FSC Report

ACP-323254-25

Appeal against Condition 6

The Coast, Block B, Woodbrook
Avenue, Woodbrook, Co. Dublin

FIGURE 6

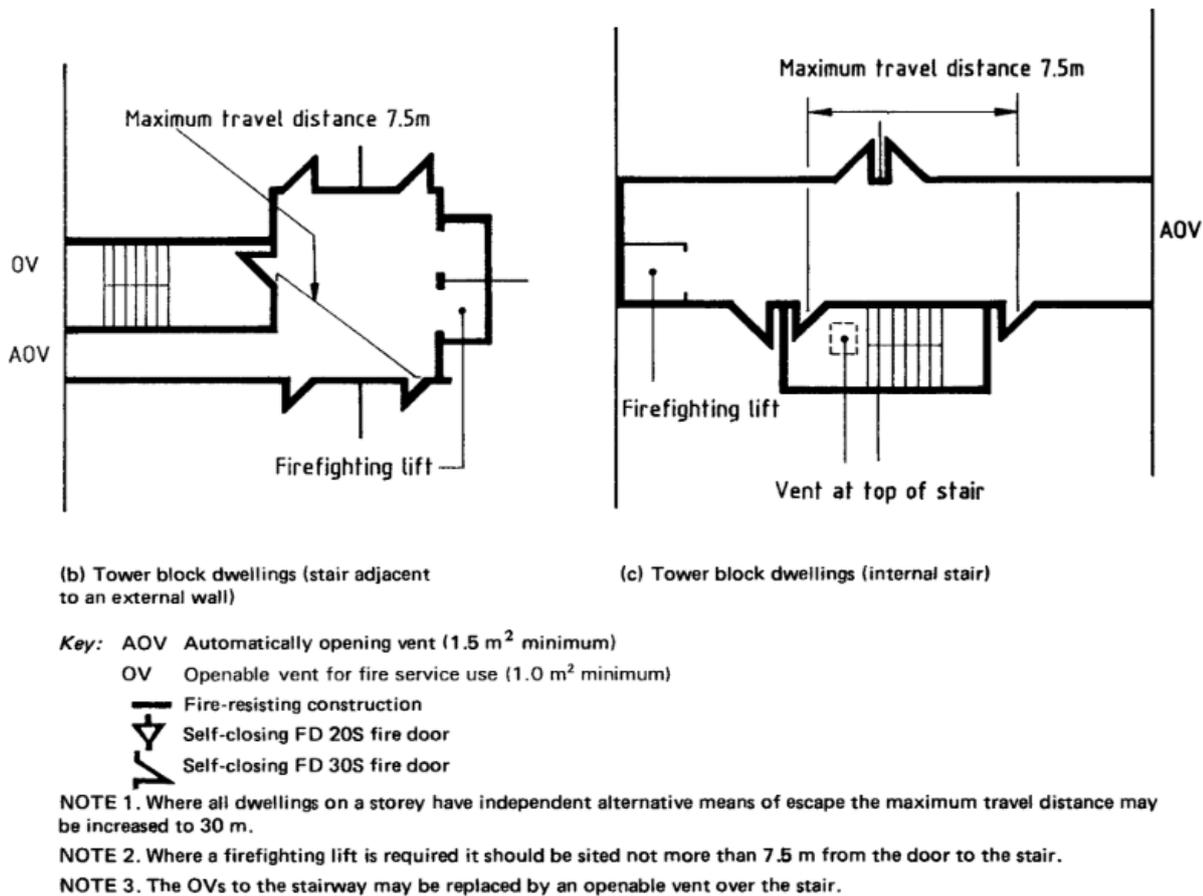
In particular, reference is made to diagrams Figure 12 (b) and (c) of BS5588: Part 1 which shows the lift shaft opening directly into a ventilated lobby/corridor without the need for any additional provisions (Figure 6 below).

The argument is made that the lifts in the proposed development are not firefighting lifts but that even if they were (as per Figure 6 above), there would be no requirement for the lift landing doors to have any smoke leakage rating, and the lifts (in their view) could open directly into a shared common corridor.

- They emphasise the fact that the lifts in Figure 12 of BS5588 Part 1 are identified as firefighting lifts and as the proposed lifts in this block are not firefighting lifts this figure is not applicable. In addition, the case is made that even if the lifts were firefighting lifts the arrangement in Figure 12 (of Part 1) where the lifts open directly into a shared common corridor would not be acceptable. They point to Section 5.3.2 of TGD B which they say supersedes Figure 12 and recommends “a *firefighting lobby should be provided*” whereby “*there should not be direct access to a flat or ancillary accommodation from a firefighting lobby*” and a “*firefighting lift should be approached through a firefighting lobby*”.

- While they agree that Figures 12(b) & (c) refer to firefighting lifts, they make the point that there are no other figures that show the proposed design and as such these figures were the most appropriate figures to reference. The appellant argues that even though firefighting lifts are not required the guidance given in Section 7.2.3 of BS5588 Part 5 clearly distinguishes that common corridors in residential

- With regards Figures 12(b) & (c) of BS5588 Part 1, while I agree that there is no figure in this standard that reflects the design being proposed by the appellant, I would share a similar view to that of the BCA. The figures referenced in BS5599 Part 1 show firefighting lifts opening directly into the common corridor which would not be acceptable under Section 5.3.2 of TGD B. Diagram 33 of TGD B clearly shows that a building provided with a firefighting lift must opening into a dedicated firefighting lobby and not into a common corridor.

FIGURE 9

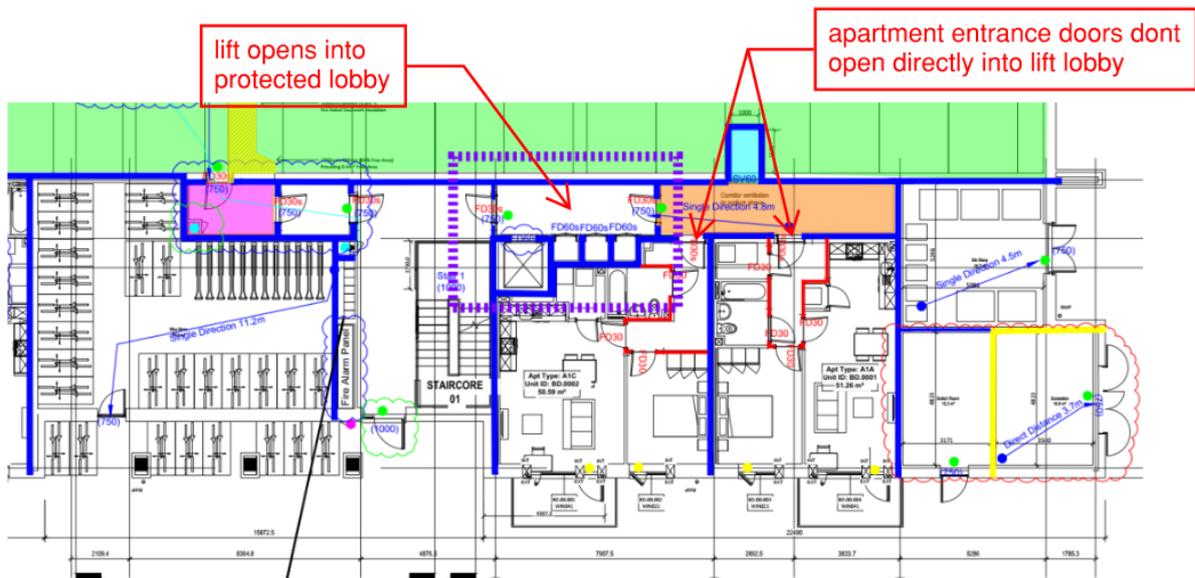
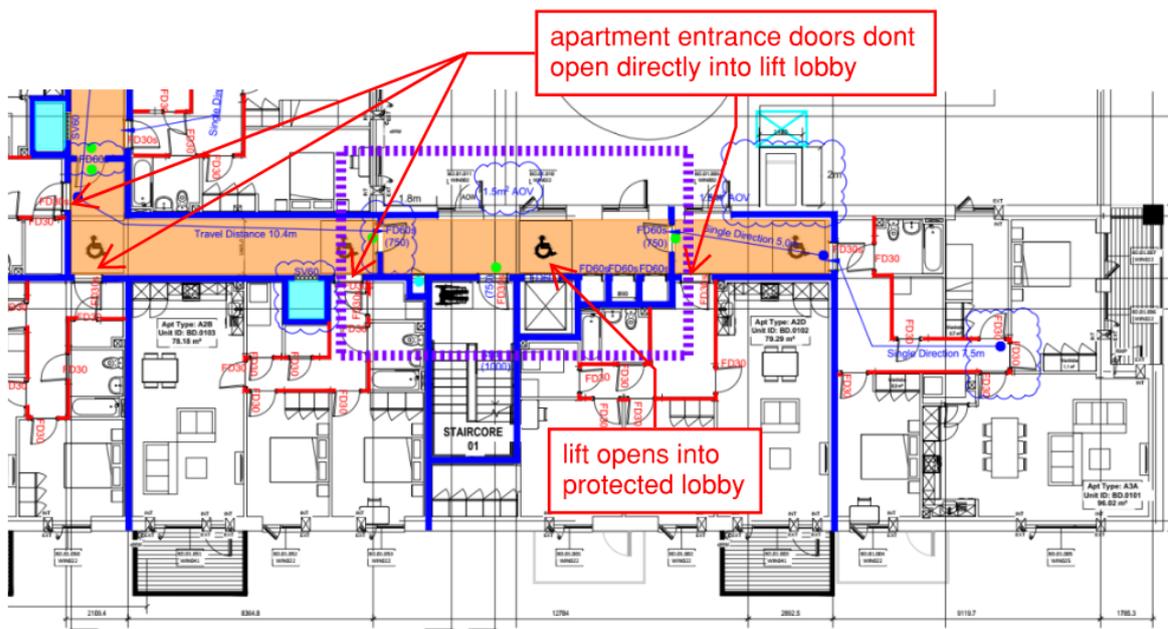
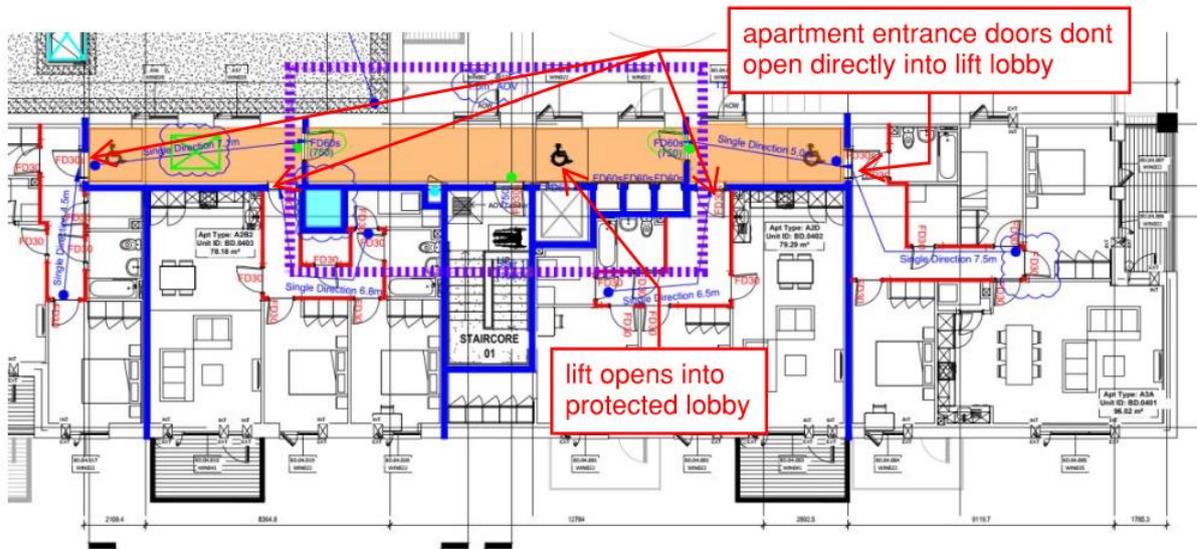
- The lift shaft in Block D opens into a lift lobby with no apartments opening into it
 - The lift shaft in Block 60 either opens into a vented lift lobby serving only one apartment per floor with a short travel distance <5.5m (ground, first and third floors), or alternatively it opens into a vented corridor which is provided with an alternative means of escape allowing occupants to turn their back on the lift (second floor)

The plans for Block D included in the BCA report clearly show that the lift opens into a protected lobby that has no apartments opening directly off it, see below.

As can be seen from Figures 9-11 above, the lift lobby arrangement in Block D layout bears no similarity to those being proposed in Block B.

FIGURE 12

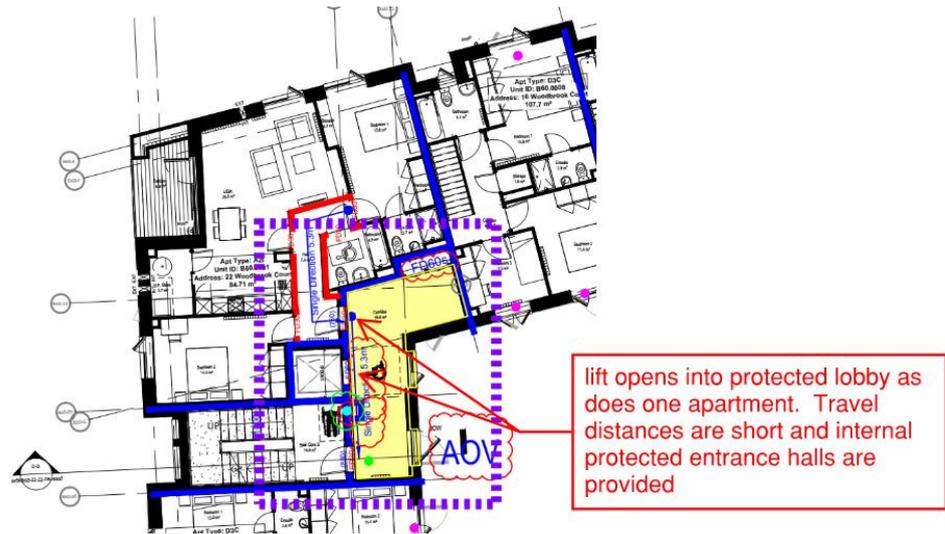
The plans included in the BCA report for Block 60, in my view, also differ to those in Block B as they show 1 No. apartment on the ground, first and third floors opening into the same lobby as the lift. The second floor has a completely different layout, as alternative means of escape is provide for evacuees on this floor.

Figure 12 below shows a typical floor layout approved for Block 60 which has the lift opening into a protected lift lobby shared with 1 No. apartment compared to Figure 13 for the proposed development which shows the lift opening into a lobby shared with 6 No. apartments. The differences between the layouts include shorter travel distances and the provision of protected entrance halls in Block 60.

On the basis of the above, I would be of the view that the layouts of Block D and Block 60 are not similar to those proposed in Block B.

FIGURE 13

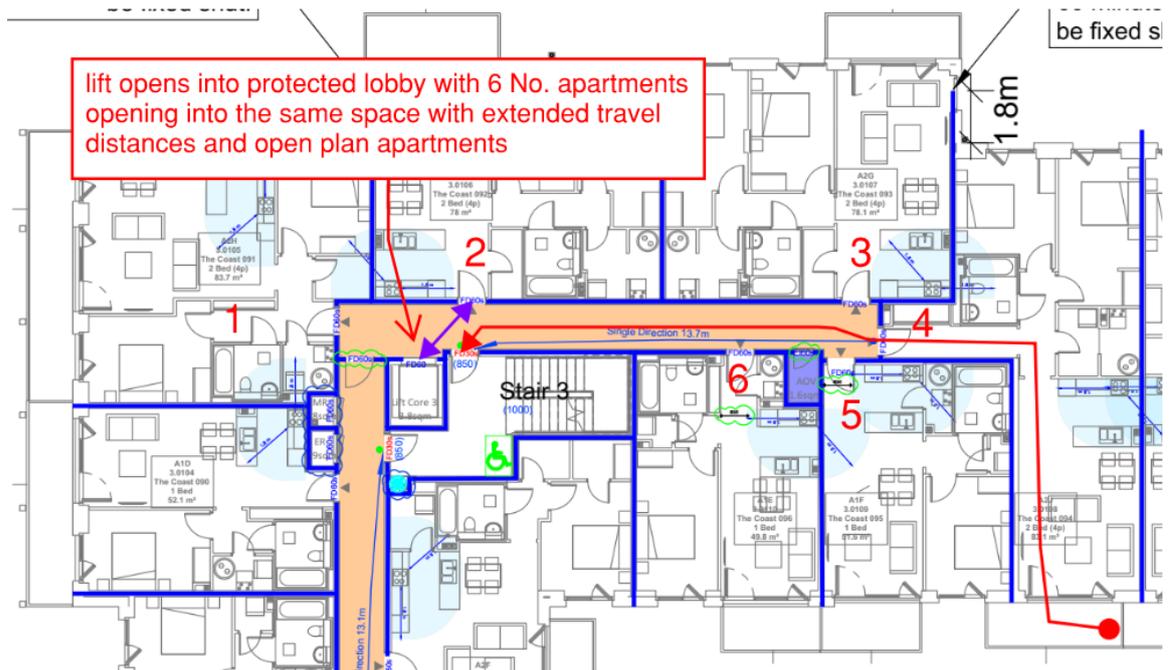
escape". They contend that with common corridor travel distances in some of the cores in Block B exceed 7.5m and are of the opinion that even with the provision of sprinklered apartments it is important to consider the potential impact the lift opening directly into the common corridors will have. In particular, they draw attention to the proposed design where the lift doors are located directly adjacent to the entrance to the stair which will result in occupants having to escape towards/pass by the lift to access the stair.
